From: [Dan Grove](#)
To: [Molly McGuire](#)
Subject: Letter on Permit 2207-019 SUB2 submission
Date: Tuesday, March 7, 2023 9:58:51 AM
Attachments: [For submission - comments on SUB2.pdf](#)

I'm writing to provide additional input on Mercer Island Permit Application 2207-019's recent [submission response memo](#) (SUB2) and corresponding revised [plans](#). On October 25, 2022, I and my attorney, Zach Davison, submitted comments during the public comment period on the initial plan set. This letter supplements those comments in response to the revised plans submitted by the applicant on March 1, 2023.

The diagram on Sheet C-2 (below) shows:

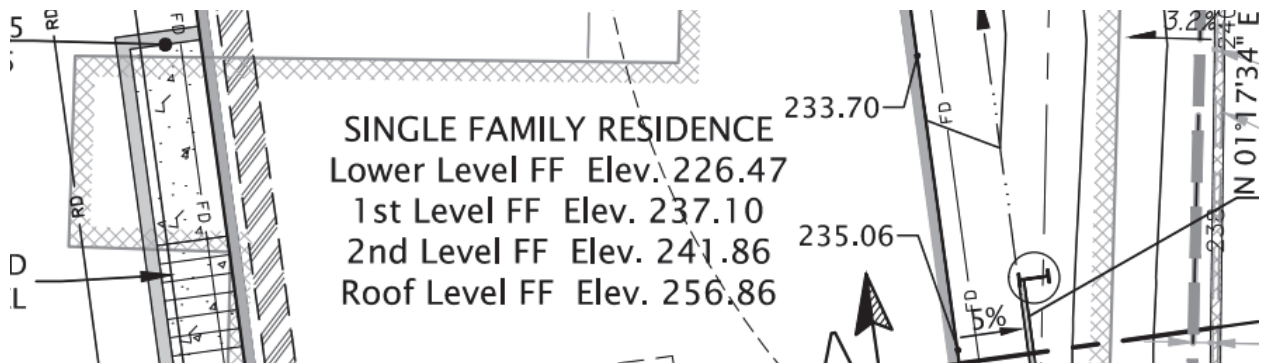
As an example of these errors and omissions, elevations shown in the plan are both incomplete and contradictory.

- Lower level FF of 226.47'
- 1st level FF of 237.10'
- 2nd level FF of 241.86' (only 4.7' above the 1st level FF)
- Roof level FF of 256.86'

While Sheet A3.1 (below) shows:

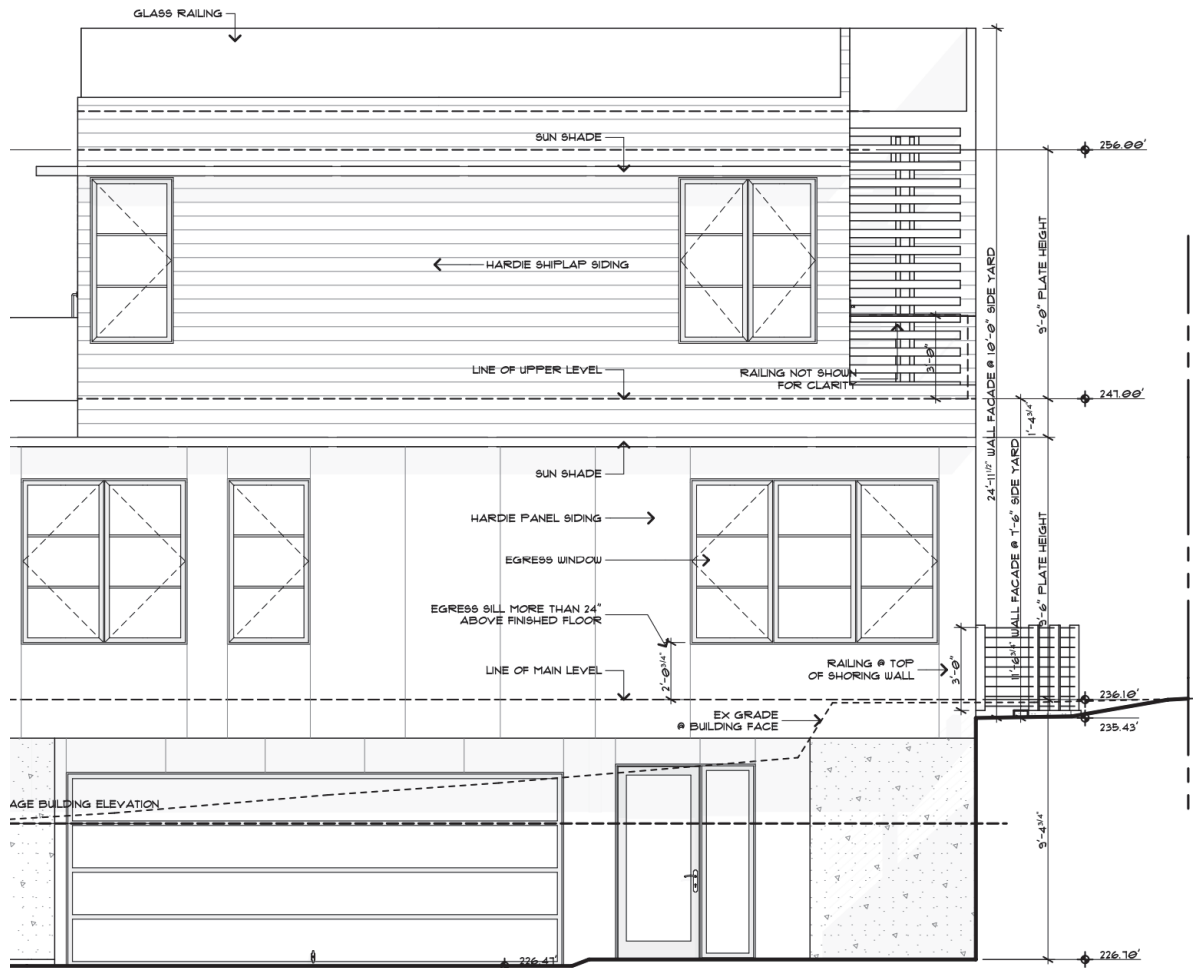
- Lower Level FF varies between 226.47' and 226.70' (differs from C-2)
- 1st Level FF of 236.10' (differs by 1.0' from C-2)
- 2nd Level FF of 247.0' (differs by 5.1' from C-2)
- Does not show Roof level FF
- Does not show elevation of the top of the railings.

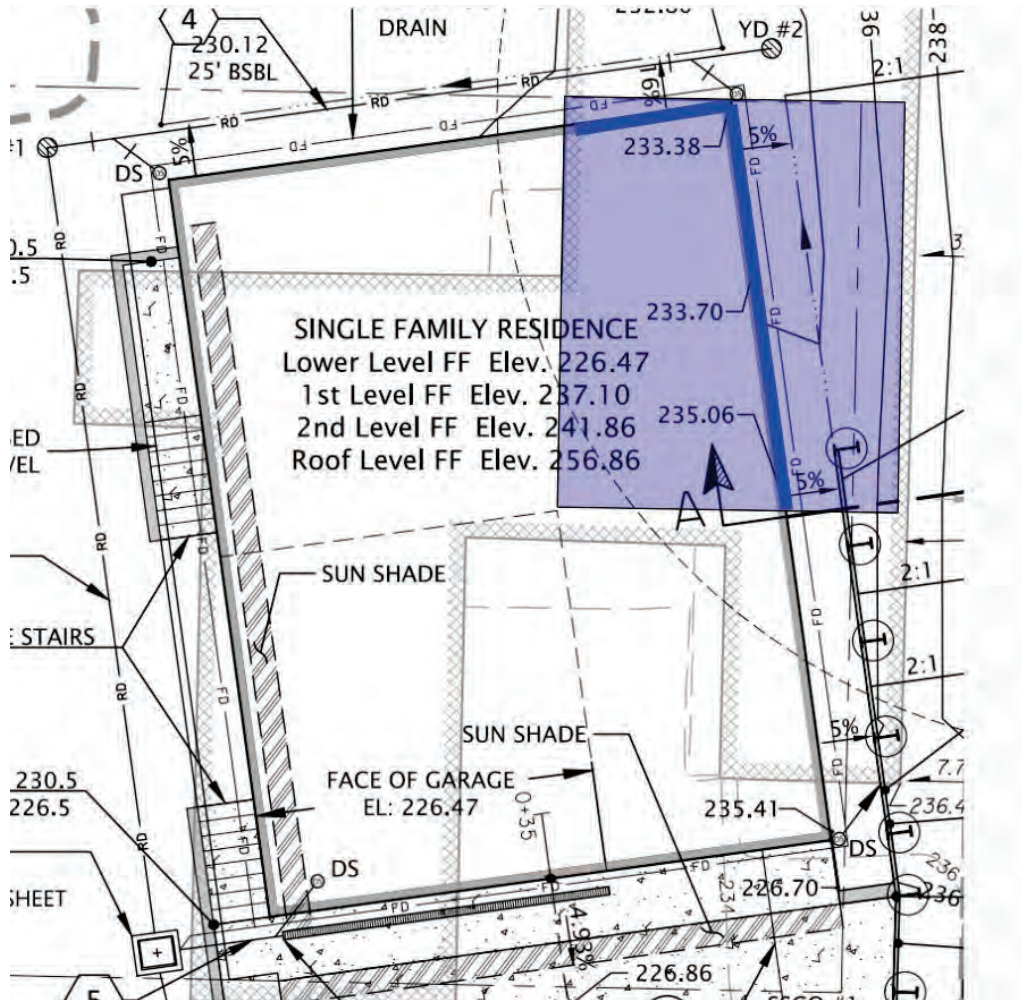
This contradicts MICC 19.02.020(E), as described in original comments from Dan Grove and Zachary Davison.

In addition, the 5/27/21 survey shows that a substantial amount of this project (and its foundation walls) sits within an existing basement that is at a 5/27/21 grade ("2021 Grade") of

228', as shown below (the existing basement at 228' is in light blue, and the proposed foundations that sit on a current grade of 228' are in dark blue).

We understand the accepted City of Mercer Island interpretation of 'existing grade' is "the grade of the lot as it currently sits" more specifically the surveyed grade prior to start of this proposed project (5/27/2021).

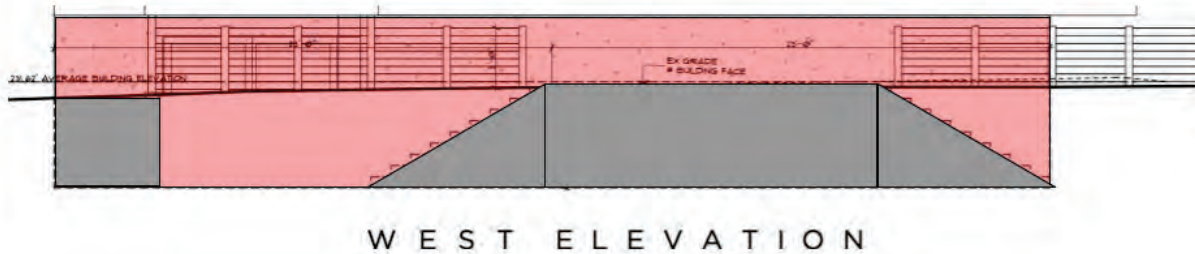
- West elevation:
 - Covered wall surface at Finished Grade shown in gray, uncovered in red. this shows coverage of ~33% based only on Finished Grade. Precise computation requires clear elevations for the ground floor ceiling and Level 1 FF, which are unavailable.
 - Existing Grade is incorrect, as shown earlier.
 - 2021 Grade appears to be correct.
 - Coverage is incorrectly computed.

North Elevation:

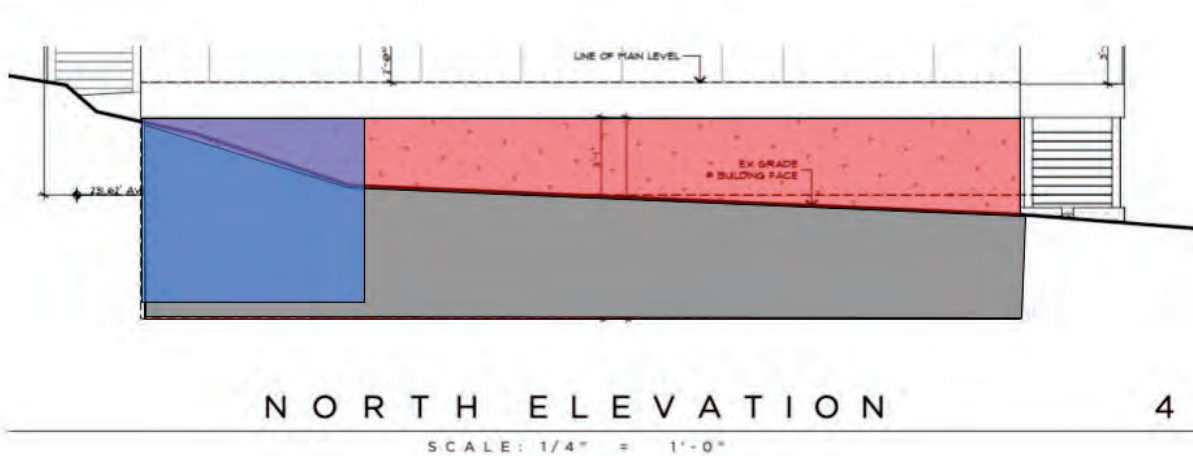
- Finished Grade appears correct.
- Existing Grade is incorrect, as shown earlier.
- 2021 Grade does not match SUB2. The blue area below shows the actual exposed wall in 2021, because part of this wall sits on top of an existing basement.
- Coverage is incorrectly computed.
